Product Change Notice (PCN)

Subject: Transfer of back-end production for general-purpose linear IC products (MSOP package products)

This notice is to notify the transfer of a Back-End Factory.

Operational amplifier ICs, Comparator ICs, Reset ICs (MSOP package products)

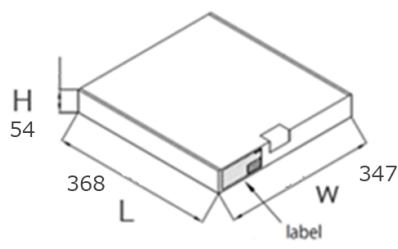
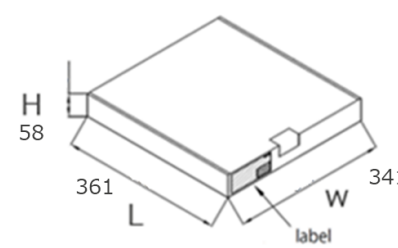
There are some dimensional differences in the outline drawing, but the recommended foot pattern remains the same.

Current products		(UNIT:mm)		HCA products		(UNIT:mm)	
ITEM	DIMENSION	ITEM	DIMENSION	ITEM	DIMENSION	ITEM	DIMENSION
D	2.90	D	2.75	D	2.75	D	2.75
D1	3.00±0.20	D1	3.00±0.20	D1	2.95±0.20	D1	2.95±0.20
E	2.80	E	2.80	E	2.80	E	2.80
HE	4.00±0.20	HE	4.00±0.20	HE	4.00±0.30	HE	4.00±0.30
e	0.65	e	0.65	e	0.65	e	0.65
b	0.22±0.05	b	0.22±0.05	b	0.20 ^{+0.10} -0.05	b	0.20 ^{+0.10} -0.05
A	1.03 MAX	A	1.03 MAX	A	1.00 MAX	A	1.00 MAX
A1	0.08±0.05	A1	0.08±0.05	A1	0.05±0.05	A1	0.05±0.05
A2	0.85±0.05	A2	0.85±0.05	A2	0.85±0.10	A2	0.85±0.10
A3	0.25	A3	0.25	A3	0.25	A3	0.25
L1	0.60±0.20	L1	0.60±0.20	L1	0.60±0.20	L1	0.60±0.20
c	0.145 ^{+0.05} -0.03	c	0.145 ^{+0.05} -0.03	c	0.13 ^{+0.10} -0.05	c	0.13 ^{+0.10} -0.05
Lp	0.37±0.10	Lp	0.37±0.10	Lp	0.37±0.12	Lp	0.37±0.12
x	0.10	x	0.10	x	0.10	x	0.10
y	0.10	y	0.10	y	0.10	y	0.10
θ	3° +5° -3°	θ	3° +5° -3°	θ	7±7°	θ	7±7°
ZD	0.525	ZD	0.525	ZD	0.50	ZD	0.50

Product Identification:

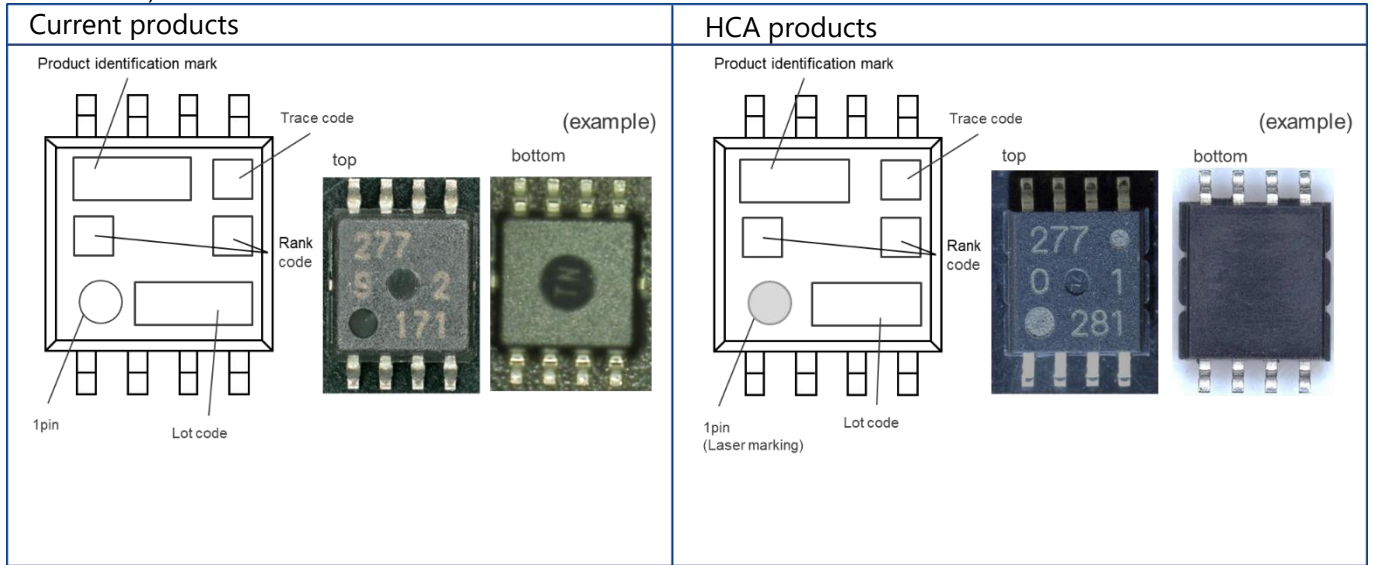
The appearance of the marking/outline (typeface, 1-pin mark, surface finish, etc.) is different, but the marking/outline information is the same. (There is no change in the marking drawing of the delivery specification.)

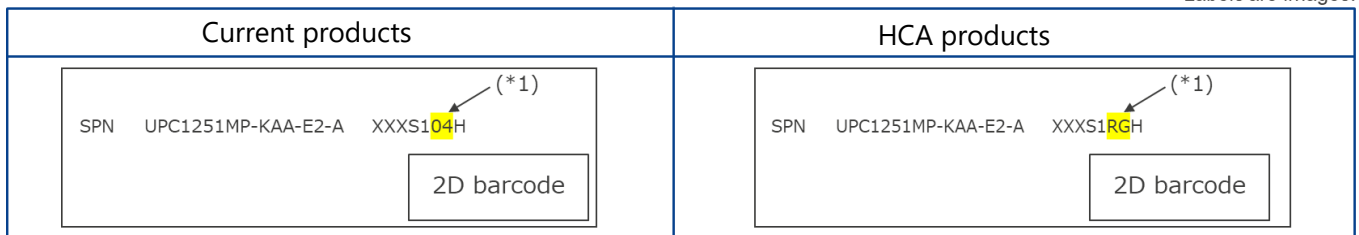
Examples of products beginning with UPC
 (*1) characters: 04 → RG

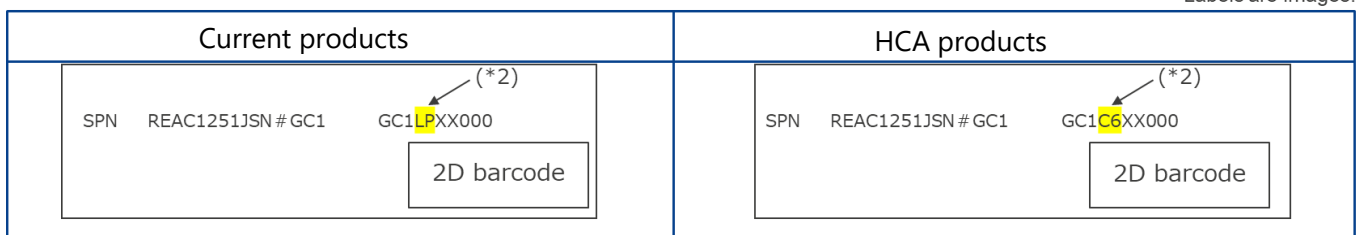
Examples of products beginning with REAx
 (*2) characters: LP → C6
